**ADDENDUM NO. 1**

**PROJECT NAME:** UNL North Stadium Sound System/Wi-Fi Enhancement  
**UNL PROJECT NUMBER:** 10420  
**BID INVITATION NUMBER:** 2332-14-7200

**DATE OF ISSUANCE:** March 17, 2014  
**DATE OF BID OPENING:** March 27, 2014

Addendum #01  
Supplemental Drawing: SDE-001  
Revision of Sheet: E1.W6  
Date: Mar. 17, 2014

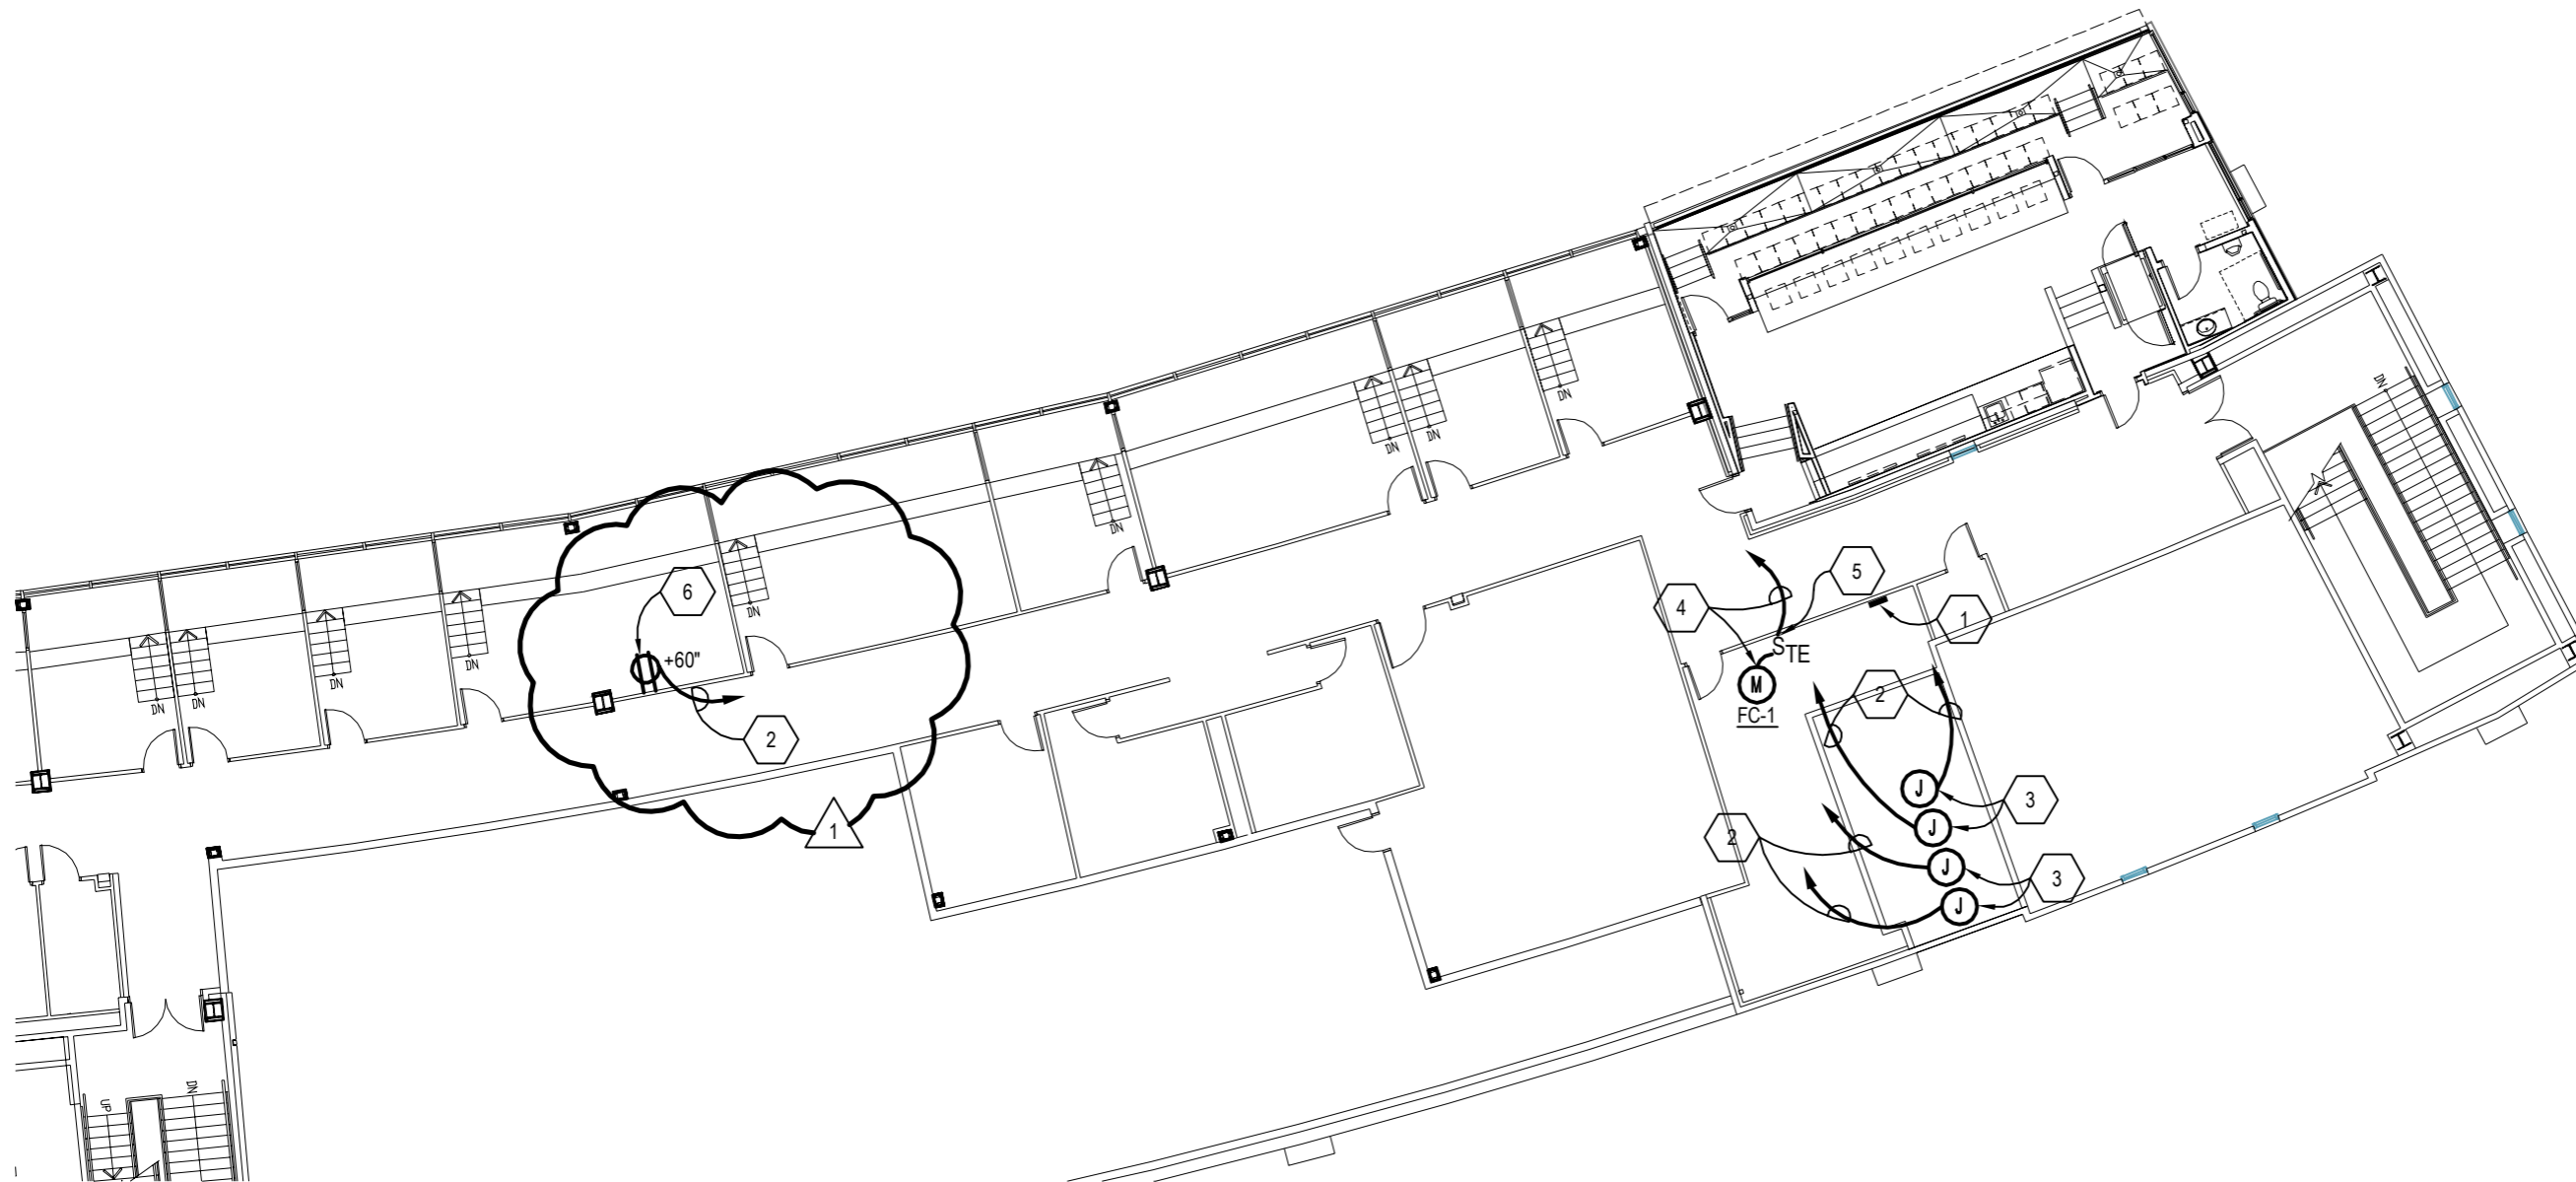
**Item #1-6 – DRAWING NO. E1.W6 WEST STADIUM 600 LEVEL – ELECTRICAL PLAN AND SCHEDULE**
